**MEMORANDUM**

REVIEW TYPE: **Site Plan Amendment Review**
 PROJECT NAME: **Brookdale**
 CASE #: **8-96026A**
 APPLYING FOR: Approval of one one-family detached
 home, one lot
 REVIEW BASIS: Required by Preliminary Plan 1-92091 approval condition # 4
 ZONE: R-60
 LOCATION: Southwest side of the intersection of Harrison Street and Murray Road,
 approximately 500 feet north of Western Avenue, in Brookdale subdivision
 MASTER PLAN: Bethesda-Chevy Chase
 APPLICANT: Dale Shields
 FILING DATE: September 10, 2004
 HEARING DATE: December 16, 2004

PROJECT DESCRIPTION: Proposal

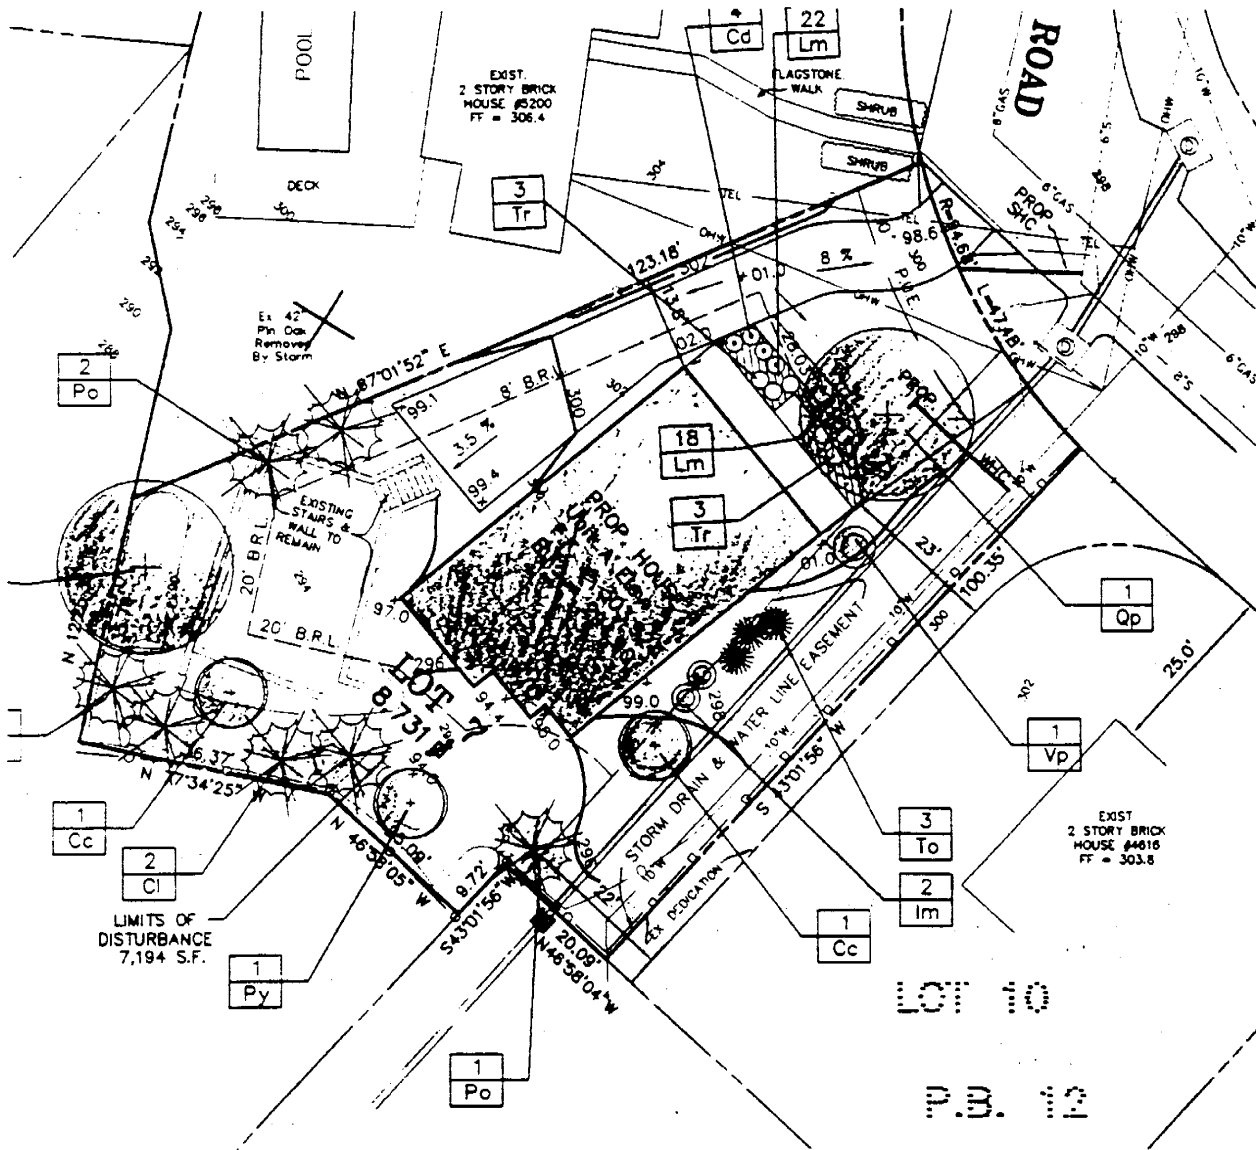
- a. Although the revised plan proposes a larger house than that shown on the approved site plan, the proposed house is still compatible with existing homes in the neighborhood in terms of building

height (26.21 feet), width (31 feet), exterior materials (painted brick), and roof material (slate or similar material).

- b. Staff agrees with the applicant on the advantages of moving the proposed house closer to the street. Although the revised front setback is less than that (50 feet) shown on the approved plan, it is still greater than the average setback (28 feet) of the existing homes along the same street. The impact of the reduced front setback on the adjacent home to the south, which has a side entrance facing the proposed house, can be addressed by the proposed landscaping along the south property line.

The proposed development consists of one one-family detached house with a driveway off Murray Road. The house is sited in the middle of the property with a front setback from the street varying from 31 to 36 feet. The proposed house is a two-story structure with a front porch. No garage is proposed. To be compatible with adjacent homes in the neighborhood, the proposed house will have painted brick exterior walls and slate roof. The existing retaining wall and steps in the rear portion of the site will remain. A number of shade, ornamental and evergreen trees will be planted near the property lines and in the front yard.

1. Preliminary Plan Conformance
 The proposed development shall comply with the conditions of approval for Preliminary Plan 1-92091 as listed in the Planning Board opinion dated January 4, 1994.
2. Architectural Compatibility
 To be architecturally compatible with the existing homes in the neighborhood, the proposed house shall be constructed in accordance with the proposed architectural elevations with the following modifications:
 - a. Use slate, or other products mimicking the appearance of slate, as the roof material.
 - b. Use painted brick as the exterior wall material.
